NATIONAL CAPITAL COMMISSION
COMMISSION DE LA CAPITALE NATIONALE

No.	2022-P06
To	Board of Directors
Date	2022-01-20

The Ottawa Hospital (TOH) New Civic Development – Phase 2
Parking Garage and Roof Park – Schematic Design

- To obtain Federal Land Use and Design Approval (FLUDA) for The Ottawa Hospital's New Civic Development (the 'Proposal') Phase 2 Schematic Design for the parking garage, roof park and associated site mobilization projects.

Pedestrian and Transit Circulation

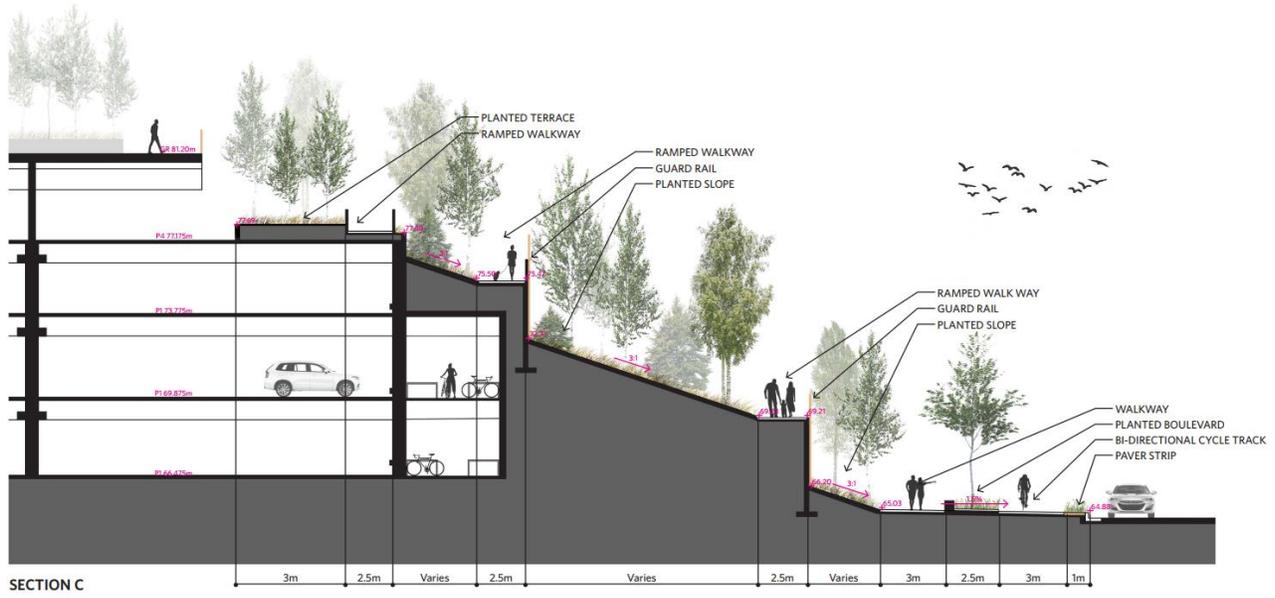
- Visual and physical connectivity with Carling Avenue, Dow's Lake, Commissioner's Park, and the LRT station should be emphasized
- Road sections should be reduced to two lanes as a speed reduction measure
- Green spaces should be maximized rather than simply optimized to mitigate heat island phenomenon
- Concerns were raised on the length of the building and the perception that it could act as a barrier to the site

- Simple programming was encouraged in order to facilitate maintenance in the long term
- Concerns raised with respect to the security of the roof space and its' hours of operation

- Ventilation and mechanical elements in the parkade and the covered pedestrian link (highline) could be designed in such a way as to contribute to wayfinding
- Consider using a different material for the exterior grid as timber requires extensive maintenance; other materials, such as terra cotta or weathering steel, allow vegetation to climb and grow and offer similar aesthetics
- Use wood for locations that are easily replaced, benches, decks.
- Anticipating the future of the car industry and adjusting the size of parking spaces to accommodate smaller vehicles as well as electric vehicles and car-sharing programs
- Stair tower exits should be integrated with the landscape and be recognizable
- Consider including retail (café) at grade near important intersections

- Consider medicinal plantings accompanied by interpretive panels as a meaningful representation of Indigenous communities
- Consider using planting boxes rather than mounds on the top floor of the parkade

- Concerns raised whether the path would generate enough attraction
- Adding respite areas and exits along the folded pathway could add to its accessibility and use
